**APPROVED**  
Limited building only review  
Permit holder responsible for full compliance with the code

PROJECT:  
3 BR SFD

CLIENT: ROBERT WIGGINS  
PROJECT: NEW SFD  
LOCATION: BROADWAY NC

# Wiggins Residence Broadway NC

**Proposed Floor Plan**

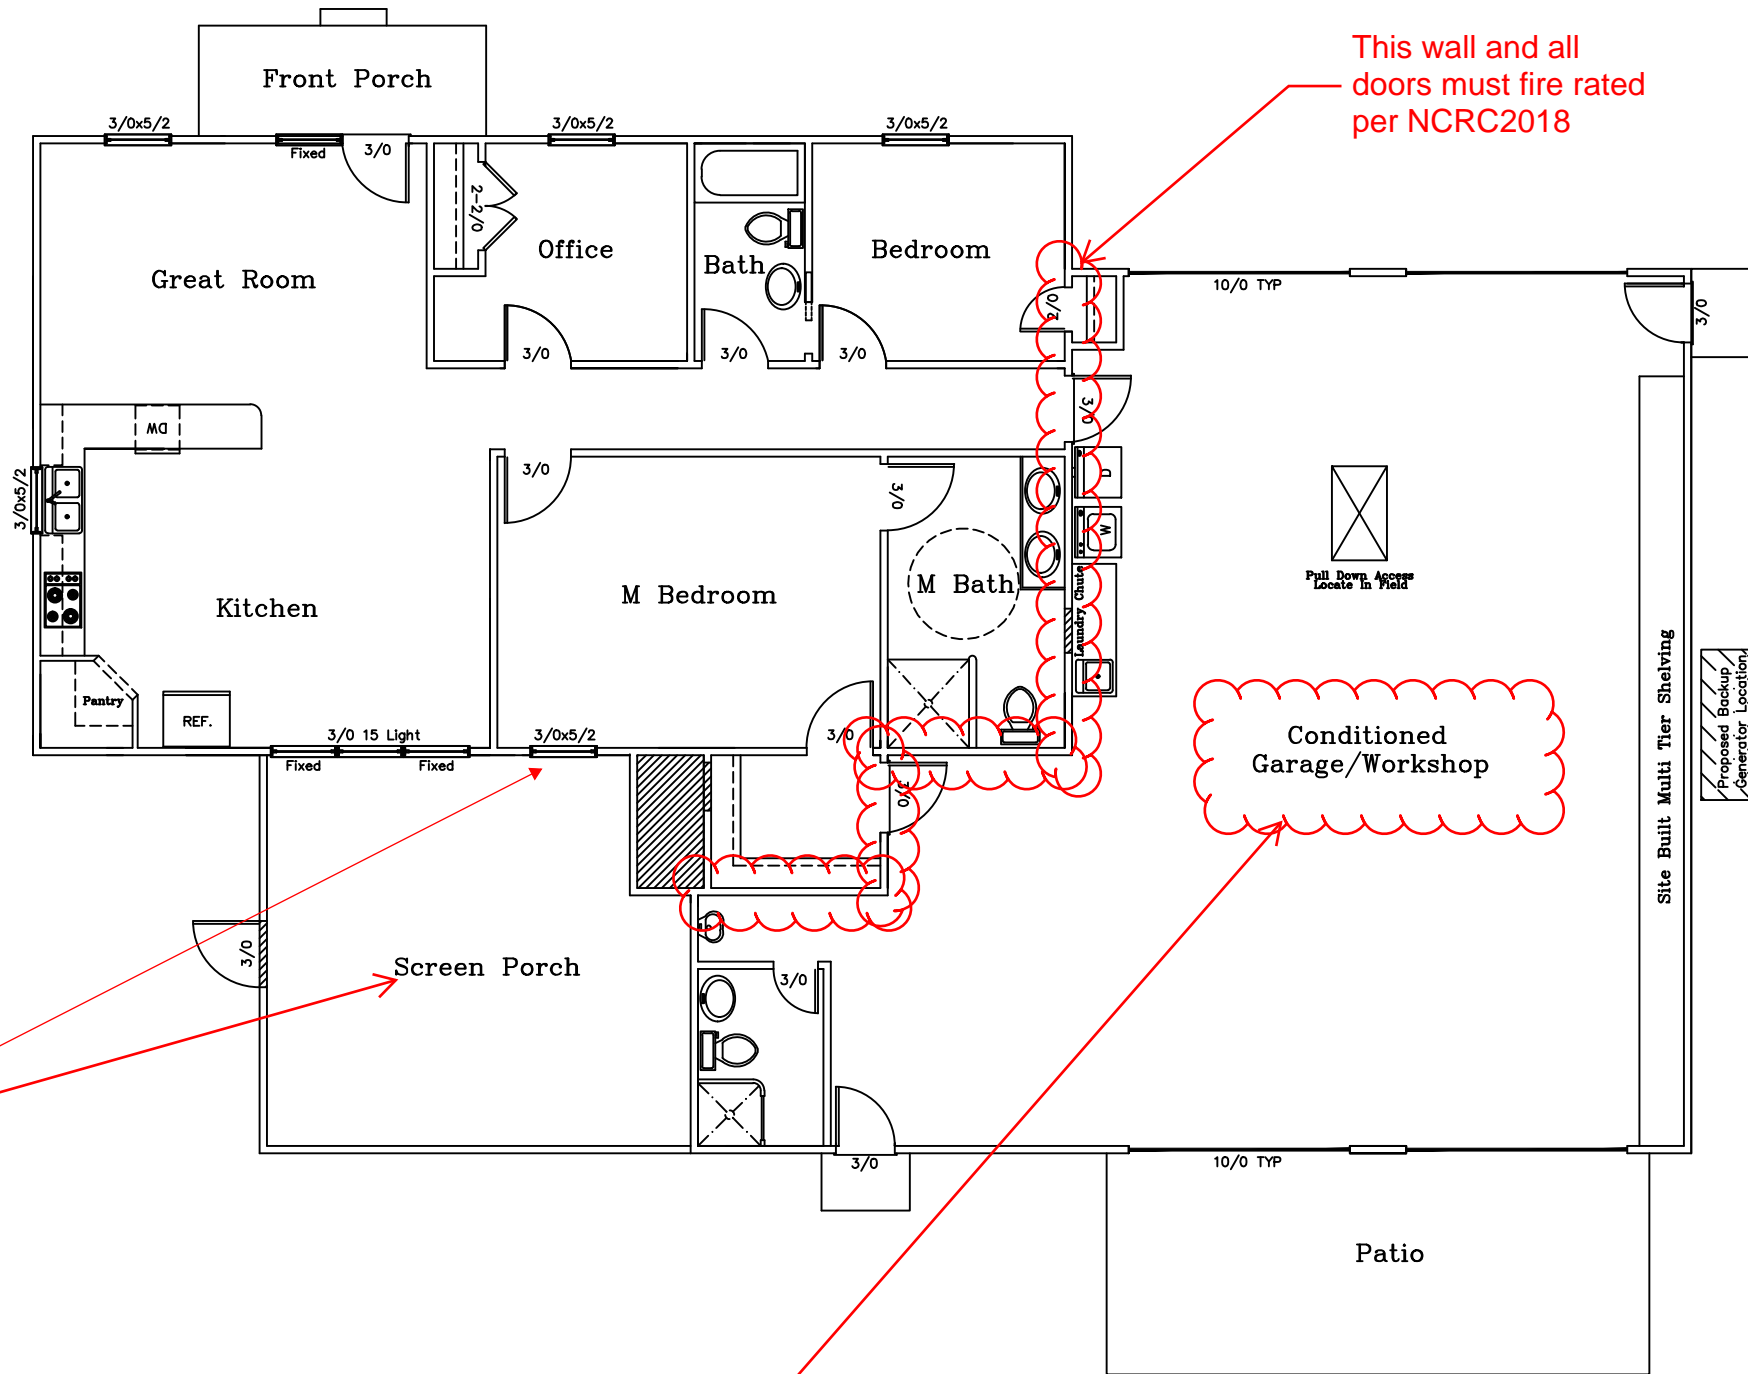
This area may not be enclosed beyond screening due to egress route

System for garage must be a completely separate system from the house.

This wall and all doors must fire rated per NCRC2018

STEP-DOWN. BETWEEN HOUSE & GARAGE  
3/4" = 1'-0"

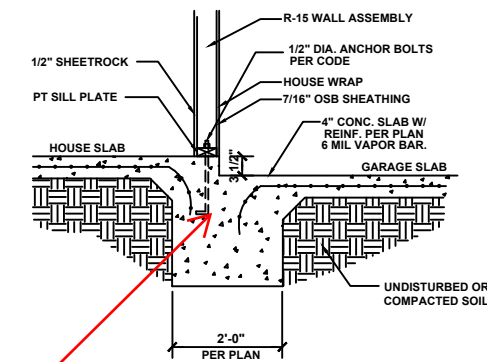
R-10 Slab insulation  
required

**Wiggins Resd  
Roof Trusses  
2' OC, 1' OH**

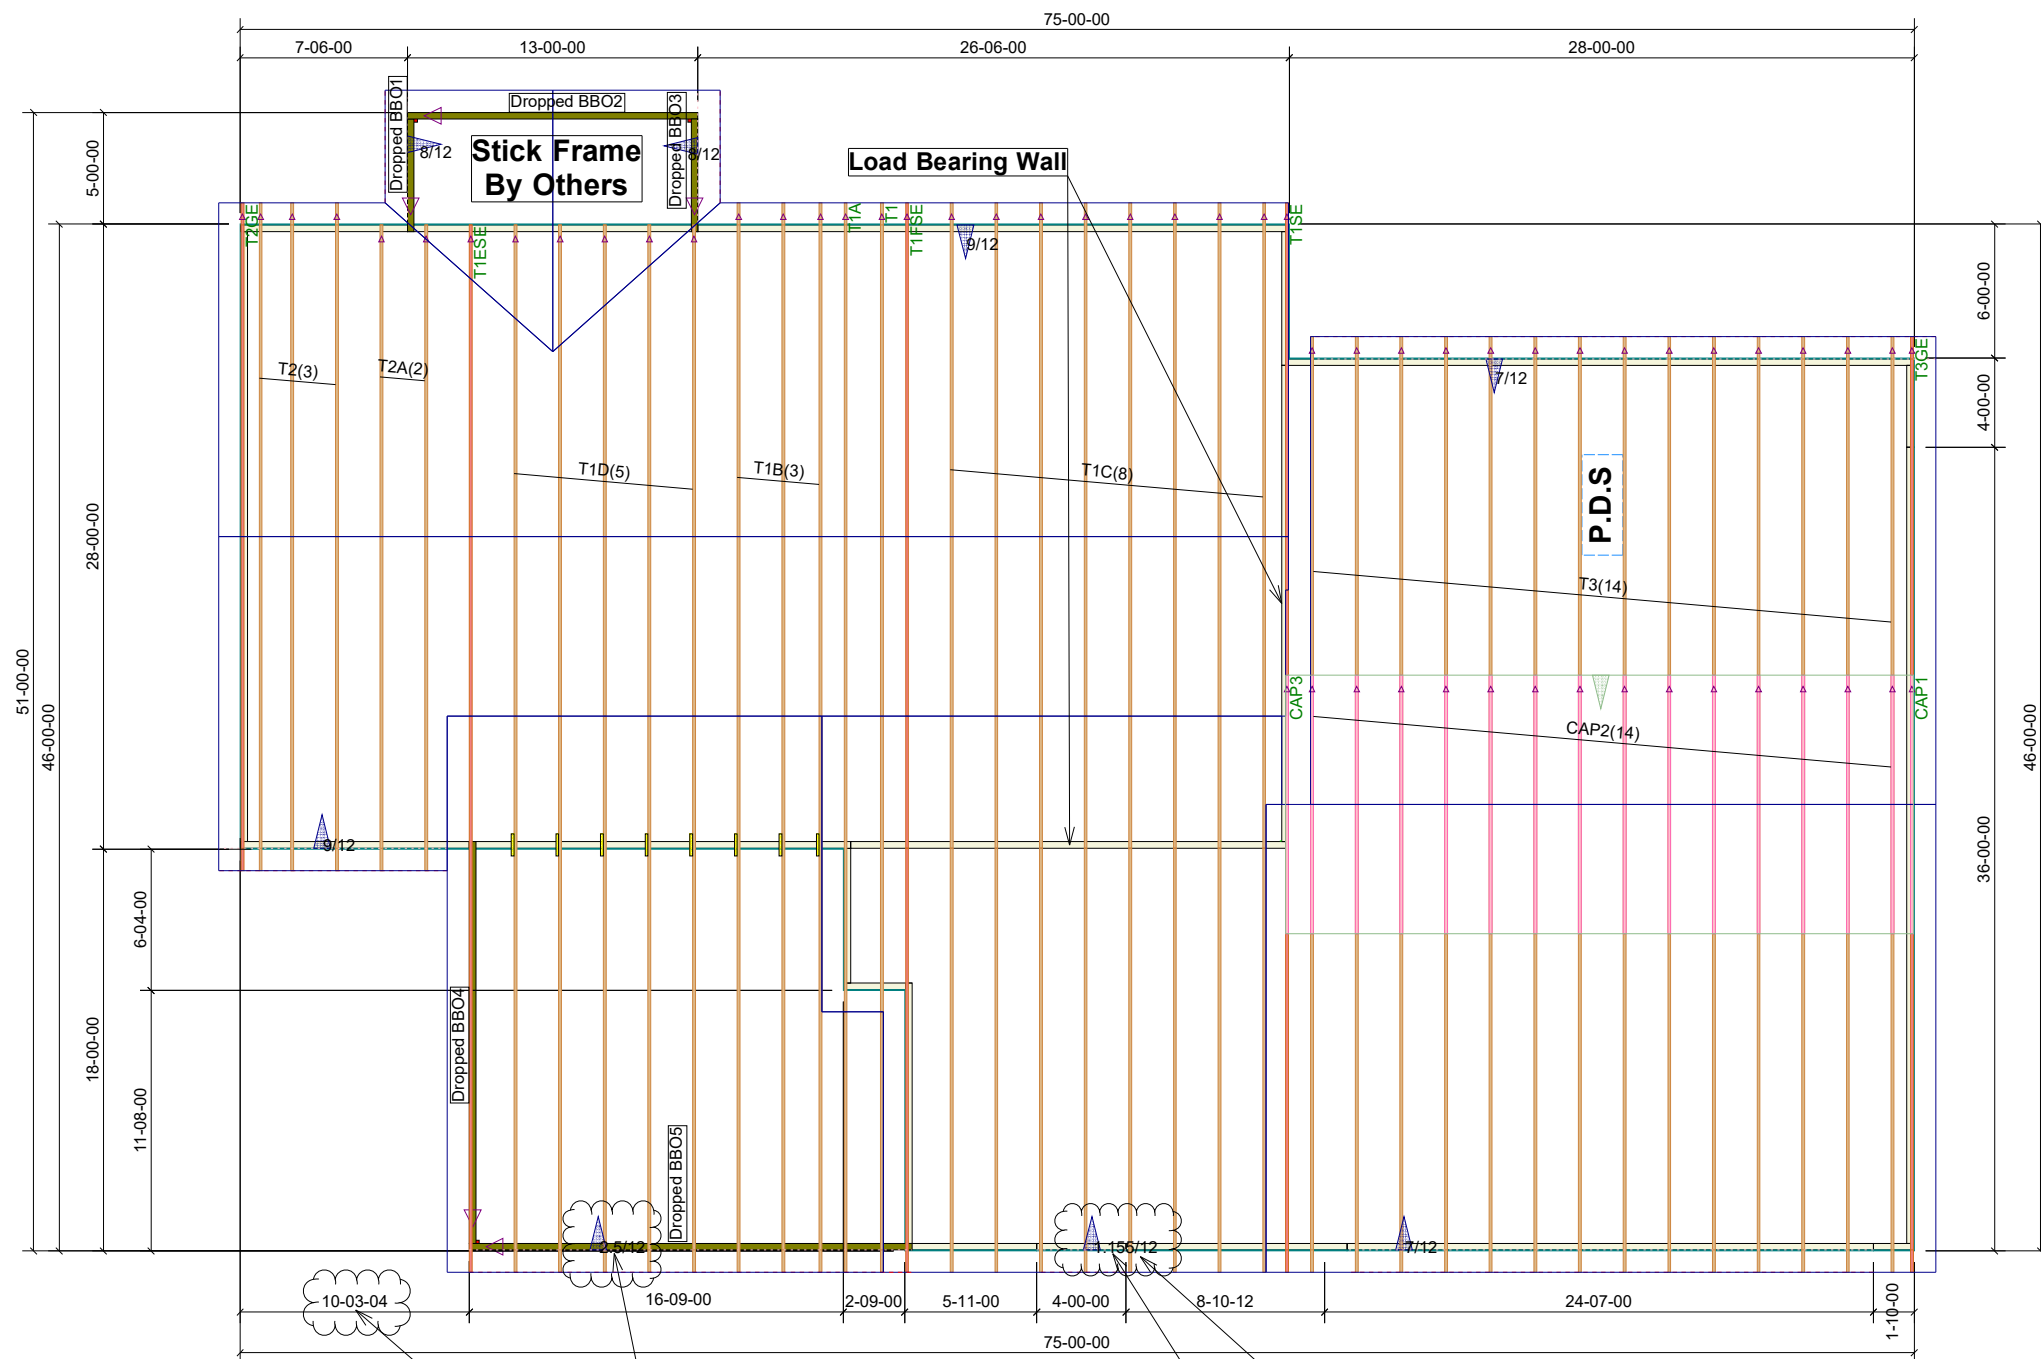
The dimensions shown on plans appear to conflict. This dimension has been adjusted so that it achieves the overall 75' dimension shown on plans. Please verify.

The pitches shown on plans in this area do not give the desired roof shape shown on elevations and roof plan. Pitches have been adjusted to best match elevations and roof plan. Please verify.

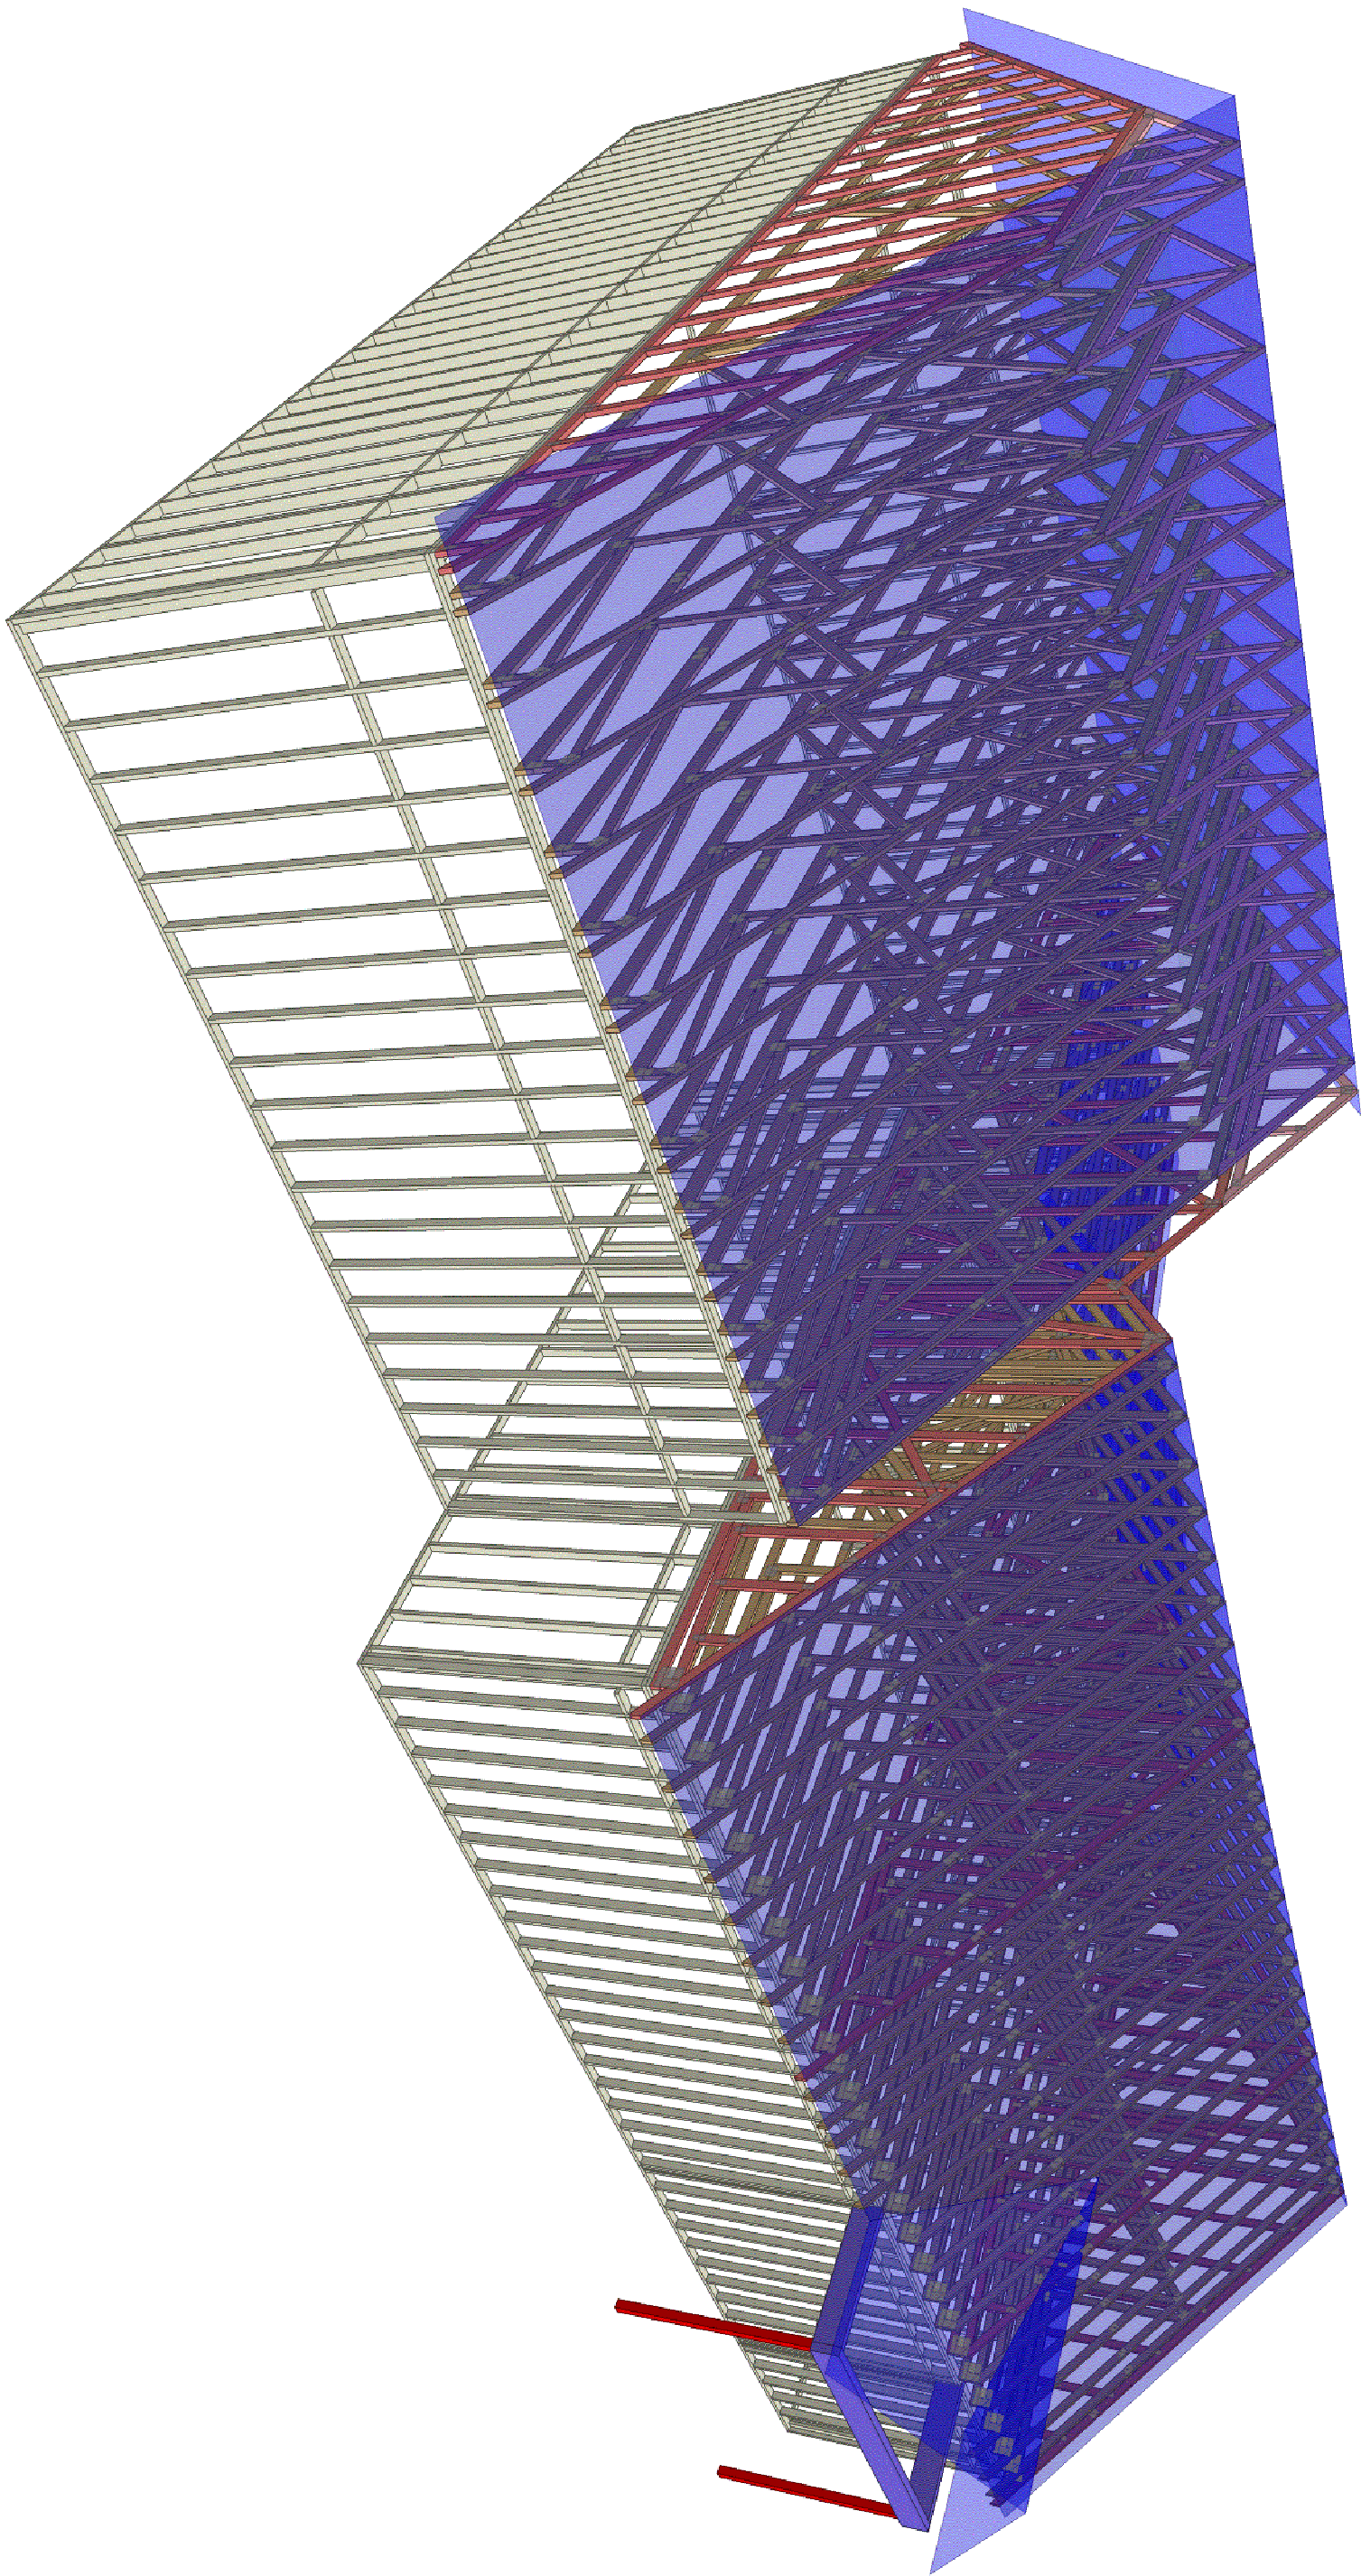
1' heel height used here for truss functionality; please verify.
